## MEMORANDUM

**RE:** 1165R Mass Ave Apartments – Traffic Peer Review Comment Responses  
Nitsch Project #13990

SHEET NUMBER:  
**C-301**

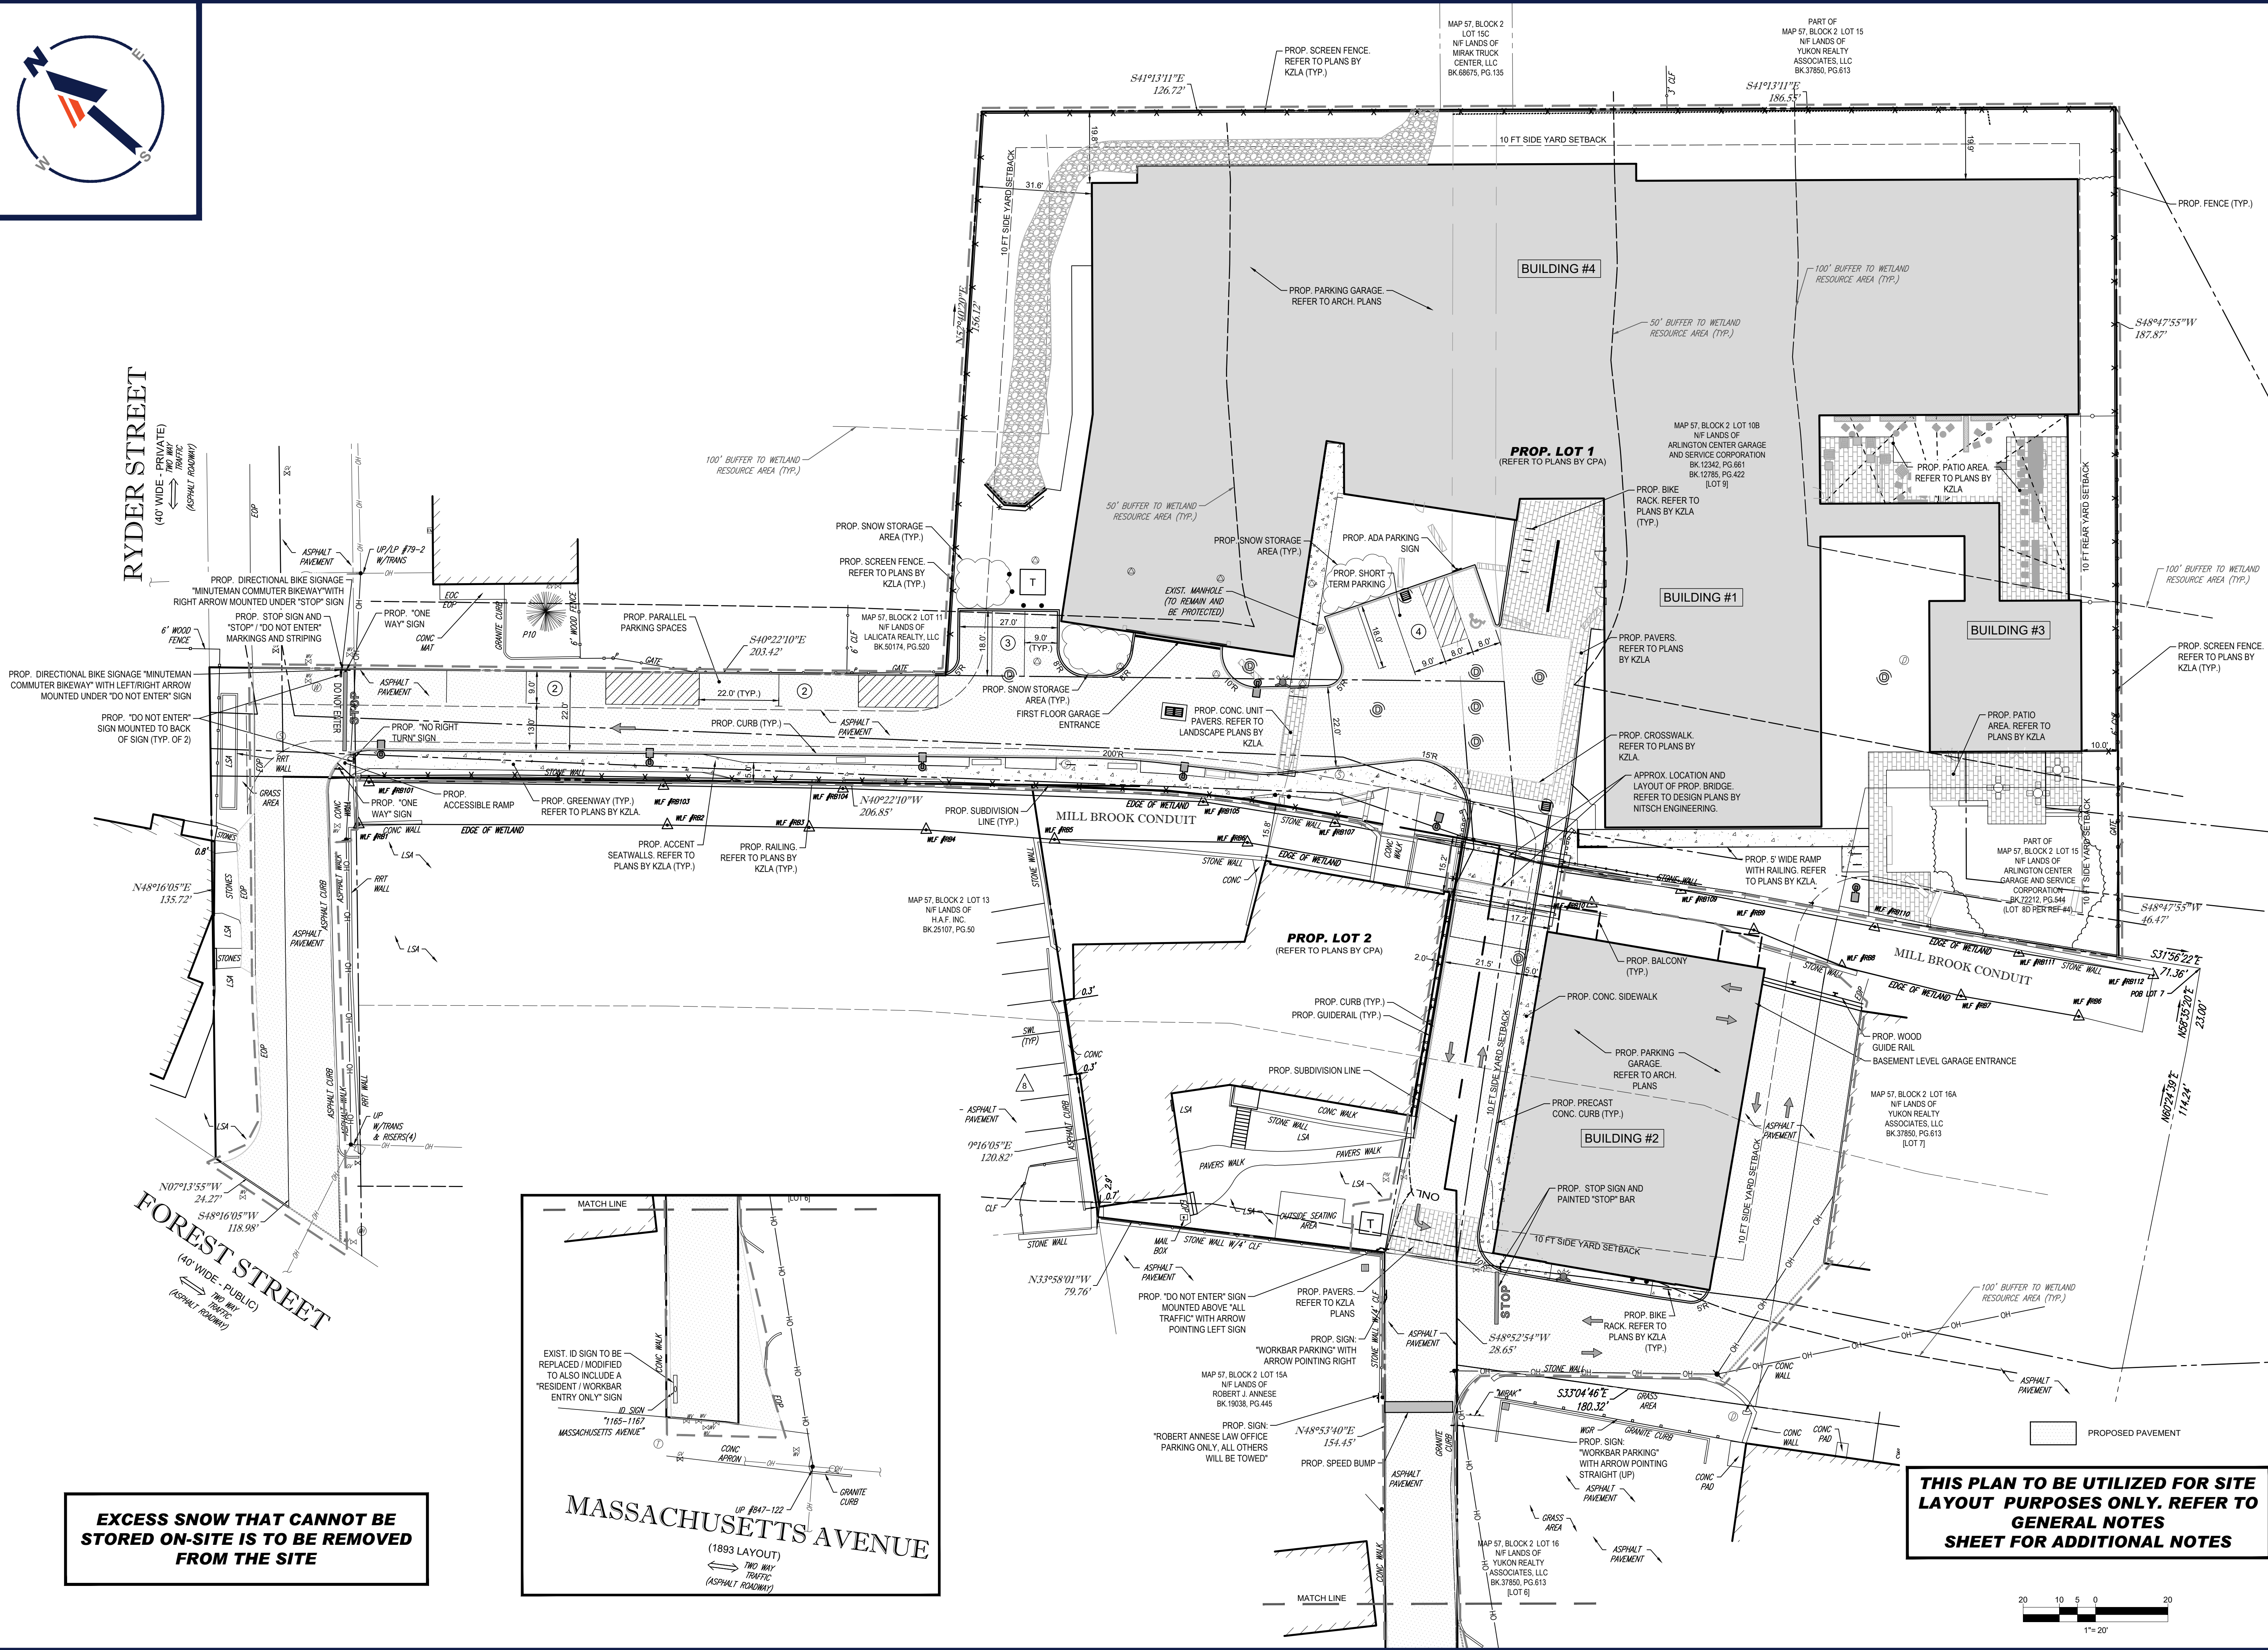
- T1. Clarify how [the driveway wayfinding] signs will be implemented. Site Plans do not propose any changes for the Massachusetts Avenue driveway.*
- R1.** The wayfinding signage has been included in the revised Site Plan package. See attached.

- T1a. Revised Site Plan package was not provided for review.*
- R1a. The revised Site Layout Plan, dated April 13, 2021, has been attached to this comment response letter for review.**

- T2. The Site Plan shows DO NOT ENTER markings for the Ryder Street Driveway, suggesting a one-way "Exit Only" condition. This is not replicated on Architectural Plans.*

- T2a. Updated Site Plans were not provided for review. Verify one-way or two-way configuration of the Ryder Street driveway.*
- R2a. The revised Site Layout Plan, dated April 13, 2021, has been attached to this comment response letter for review. The plan indicates egress-only at the Ryder Street driveway and restricted tenant egress at the Massachusetts Avenue West Driveway via regulatory signage and pavement markings.**

- R2.** The Architectural Plans depict design within the building and does not represent access to the site. The Site Plan depicts everything on-site, including access signage and markings, outside the building footprint. Therefore, it is not expected that access will be replicated on the Architectural Plans. See comment response R1.

DRAWING NUMBER  
**A004**

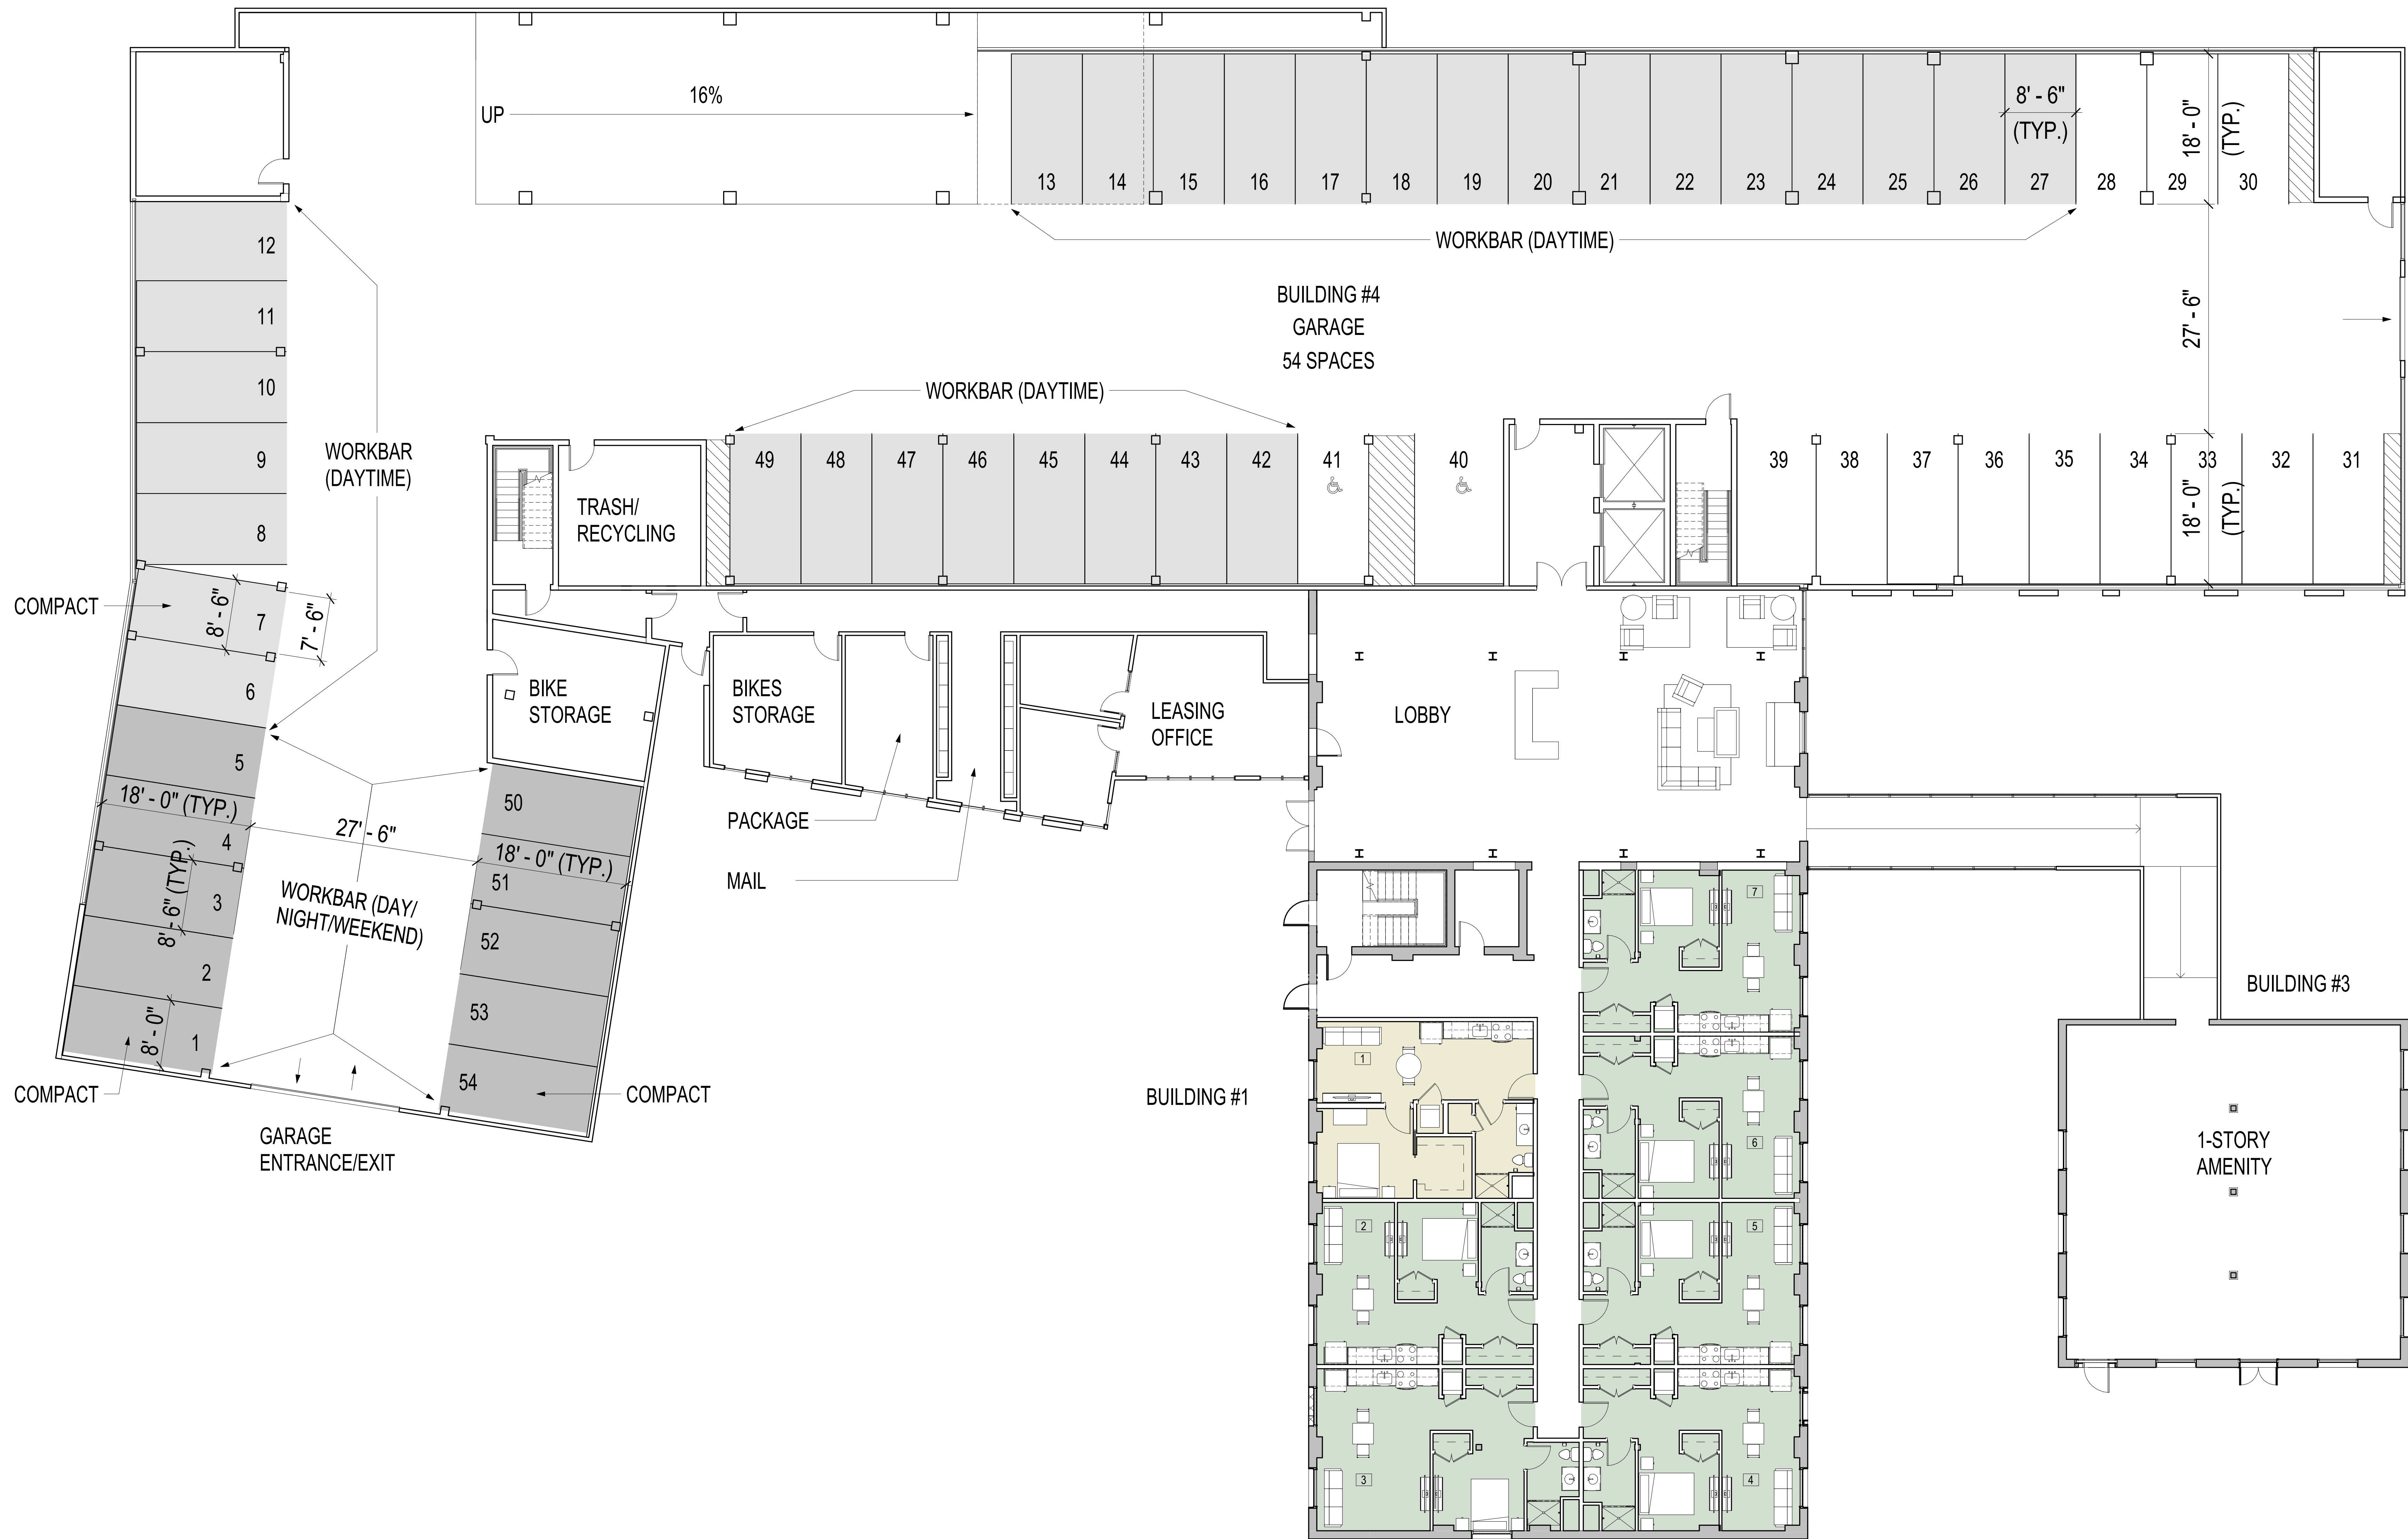
*T5a. This practice will discourage some residents from owning a vehicle, thereby reducing the parking demand. Denote space numbering on the Site Plans.*

*T7a. See Response T5. Denote space numbering and designated Workbar spaces on the Site Plans.*

*T9. One accessible parking space is provided per the Site Plans within the "Short Term" parking area. This is not represented in the Architectural Plans. Zero accessible spaces are provided in the parking garages. Confirm the adequacy of the provided accessible spaces and define adequate accessible routes to both residential and the Workbar.*

*T9a. There are two attached interior garage plans. Both show a different parking configuration. One displays the location of accessible spaces, and the other plan shows vehicle turning paths with zero accessible spaces. BETA recommends the Applicant team coordinate and provide a consistent Site Plan.*

**R5a. The parking space numbers have be denoted on the attached Building Floor Plans.**

**R7a. The Workbar parking spaces and numbers have be denoted on the attached Building Floor Plans, drawing A004.**

**R9a. The Garage Vehicle Turning Exhibit and Building Floor Plans have been revised to be consistent with each other and to show the accessible designated parking spaces. The Garage Vehicle Turning exhibit also shows the vehicle turn into the accessible space in Building 2 next to the elevator.**
